CONTRACT CHANGE ORDER MEMORANDUM

TO: Tony Anziano, Program Manager /			FILE: E.A. 04 - 0120F4	
FROM: Darryl Schram, Senior TE			CO-RTE-PM SF-80-13.2/13.9	
FED. NO. No				
CCO#: 257	SUPPLEMENT#: 0	Category Code: CHPA	CONTINGENCY BALANCE (incl. this change) \$88,321,793.04	
COST: \$1,536,378.00 INCREASE <input checked="" type="checkbox"/> DECREASE <input type="checkbox"/>			HEADQUARTERS APPROVAL REQUIRED? <input checked="" type="checkbox"/> YES <input type="checkbox"/> NO	
SUPPLEMENTAL FUNDS PROVIDED: \$0.00			IS THIS REQUEST IN ACCORDANCE WITH ENVIRONMENTAL DOCUMENTS? <input checked="" type="checkbox"/> YES <input type="checkbox"/> NO	
CCO DESCRIPTION: Cable Railing (Field Work)			PROJECT DESCRIPTION: CONSTRUCT SELF-ANCHORED SUSPENSION BRIDGE	
Original Contract Time: 2490 Day(s)	Time Adj. This Change: 0 Day(s)	Previously Approved CCO Time Adjustments: 501 Day(s)	Percentage Time Adjusted: (including this change) 20 %	Total # of Unreconciled Deferred Time CCO(s): (including this change) 3

THIS CHANGE ORDER PROVIDES FOR:

SAN FRANCISCO OAKLAND BAY BRIDGE
EAST SPAN SEISMIC SAFETY PROJECT
SELF-ANCHORED SUSPENSION BRIDGE
(SUPERSTRUCTURE & TOWER)

DIST.	COUNTY	ROUTE	KILOMETER POST TOTAL PROJECT	SHEET NO.	TOTAL SHEETS
04	SF	80	13.2/13.9	636R4	1204

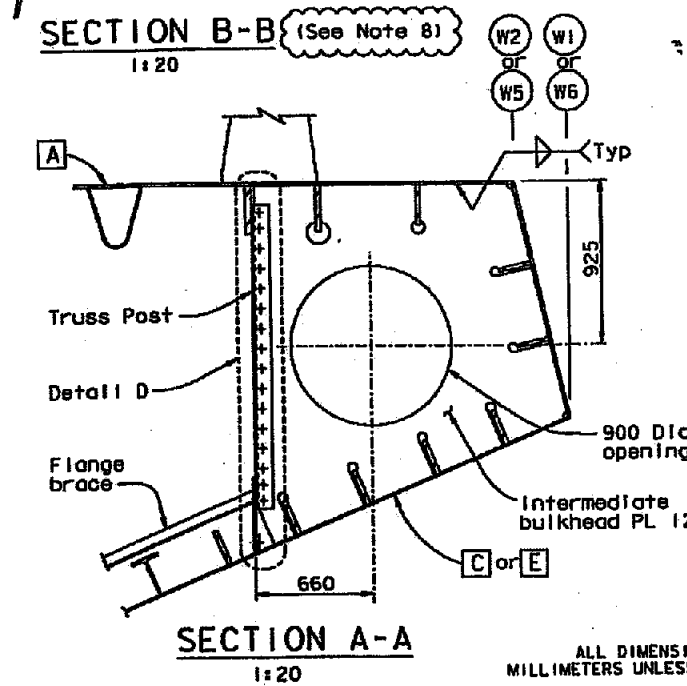
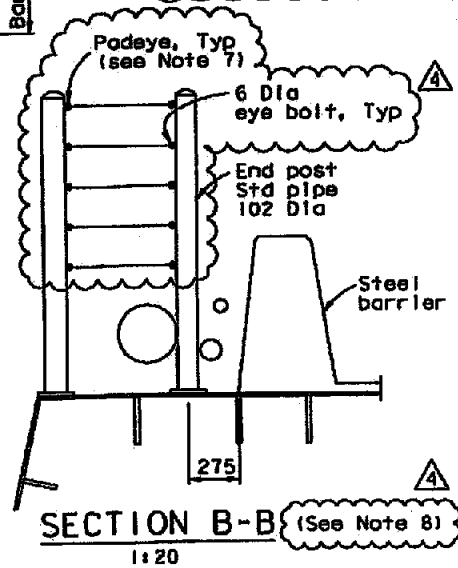
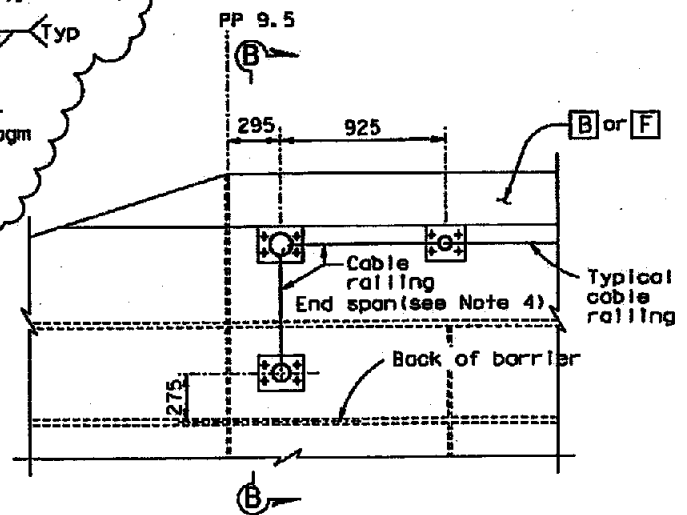
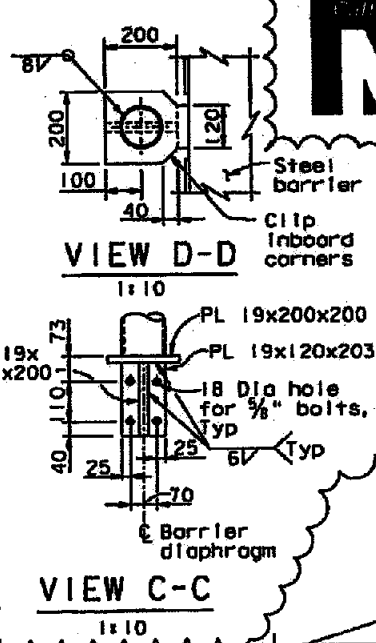
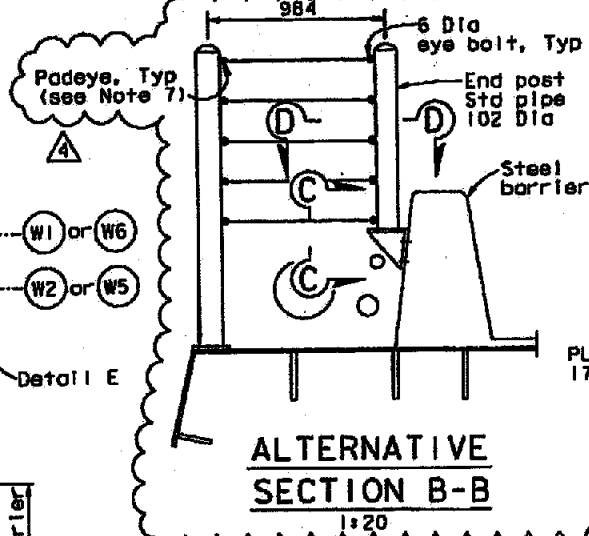
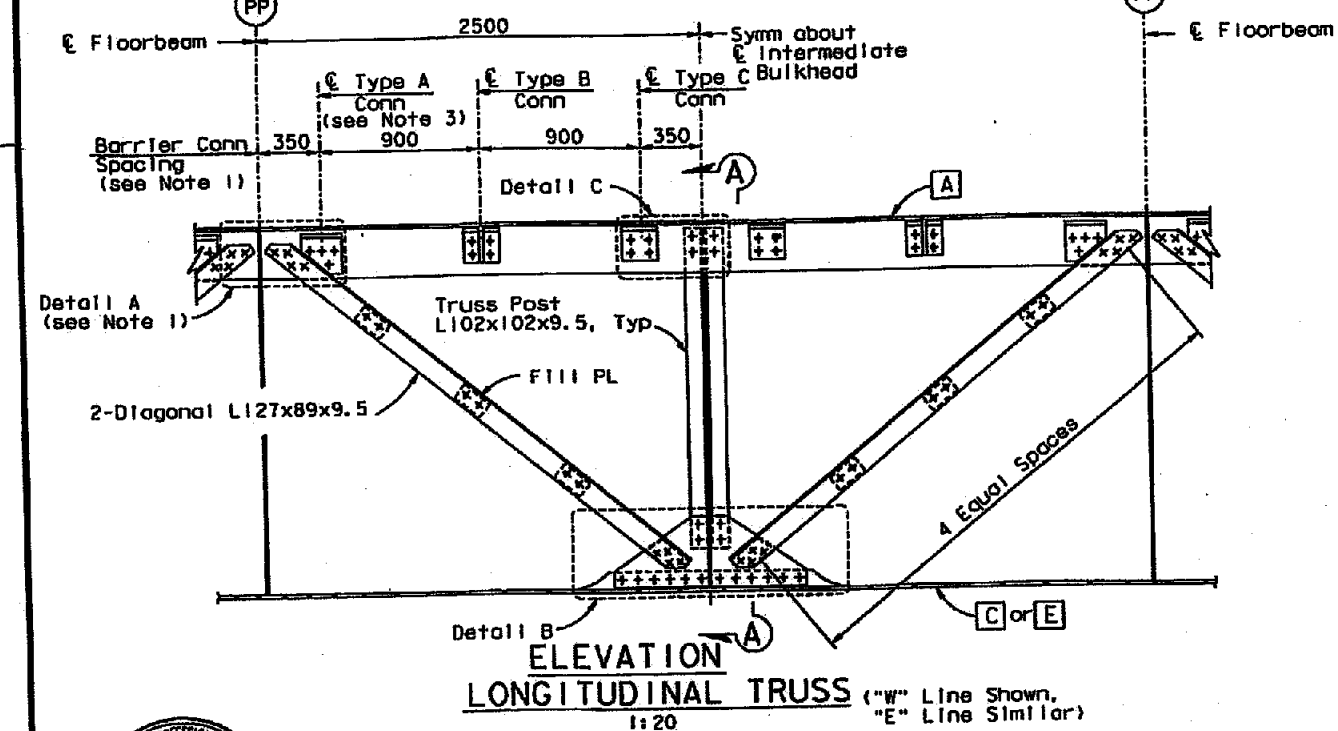
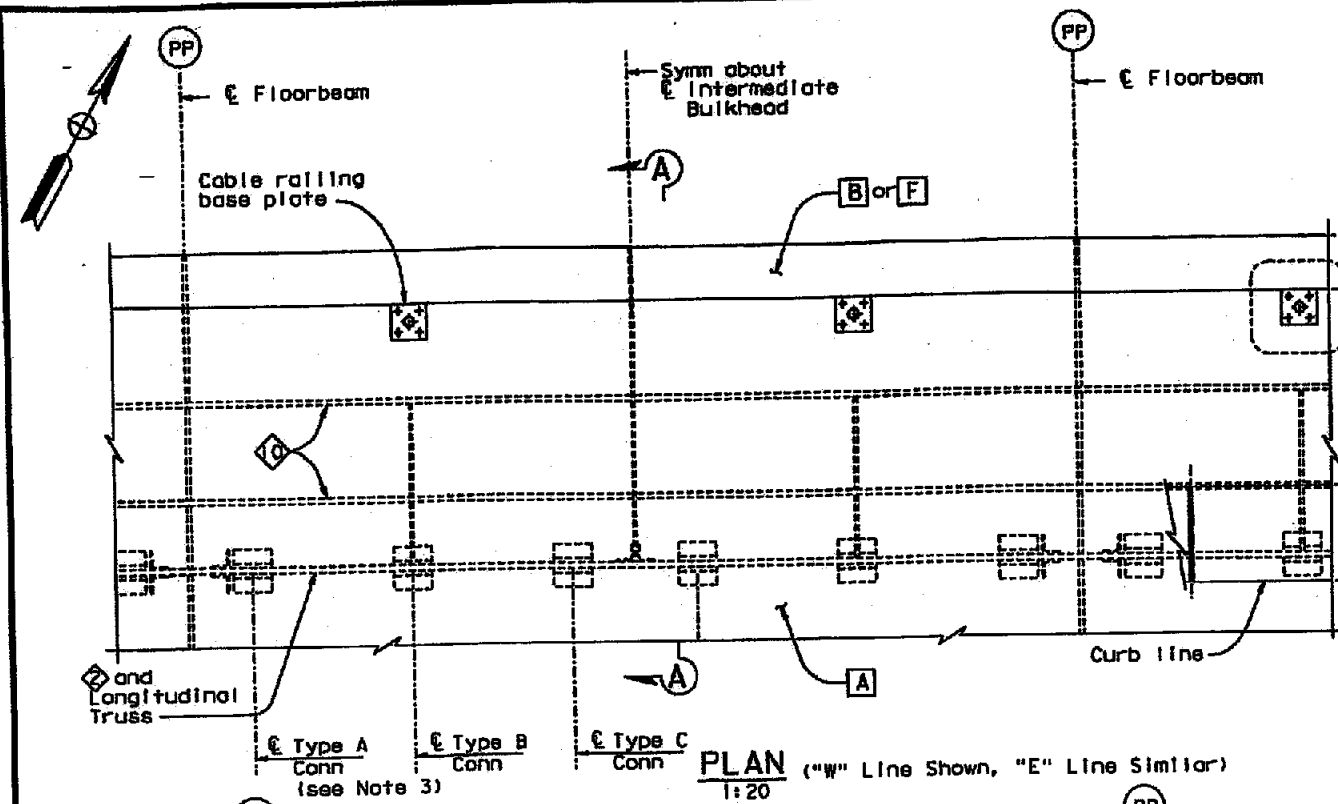
Larger diameter posts will be installed in lieu of cross bracing at OBG cable railing ends and at locations with increased post height to accommodate mechanical and electrical items. Increased post sections require wider base plates, therefore some of the bolt holes already drilled in the deck plates will be unusable. Abandoned bolt holes located under base plates will be caulked and abandoned bolt holes not covered by base plates will be plugged with bolts. Caulk will also be applied around base plates to prevent water intrusion.

The following revised plan sheets detail the changes addressed in this change order: 636R4 and 641S1R2 (of 1204) as shown on sheets 3 through 4 of this change order.

CABLE RAILING - W2 LINE (E2 Similar) (See Note 12)
1:30

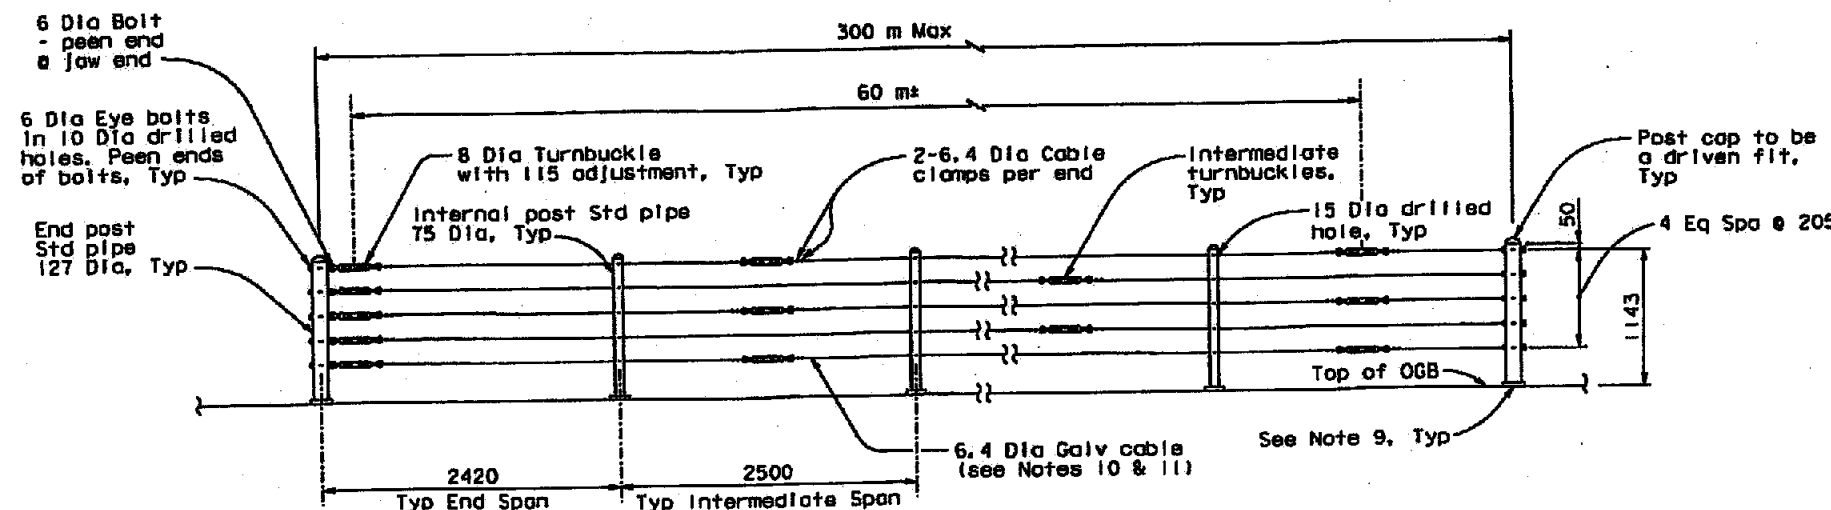
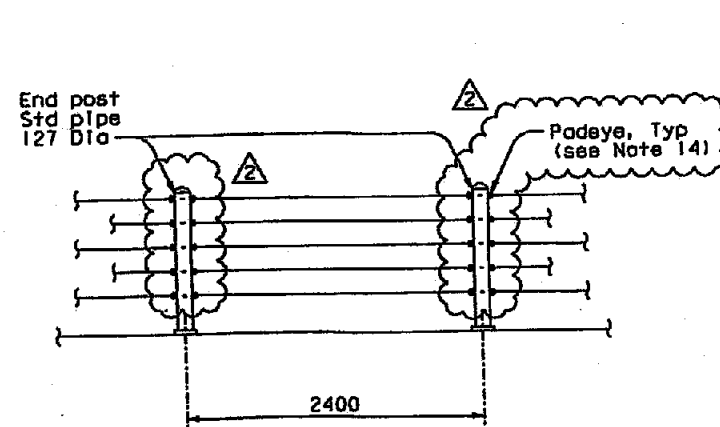
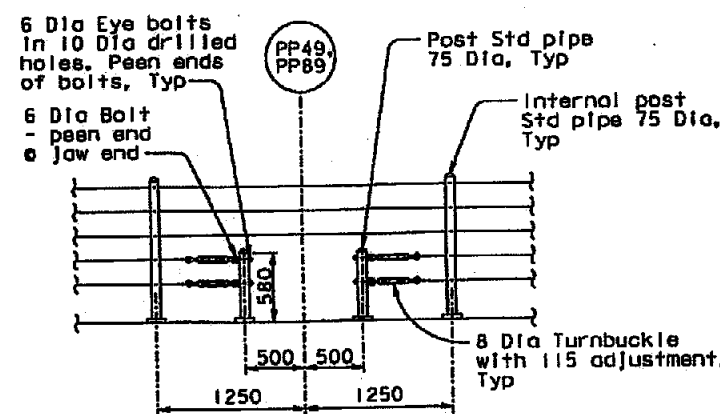
- A plastic boot or tape of the heat-shrink type shall be applied to the cable where it connects with fittings. The boot or tape shall extend over the fitting at least 25 mm.

- Padeyes shall be Crosby 1-1/2 or equivalent.
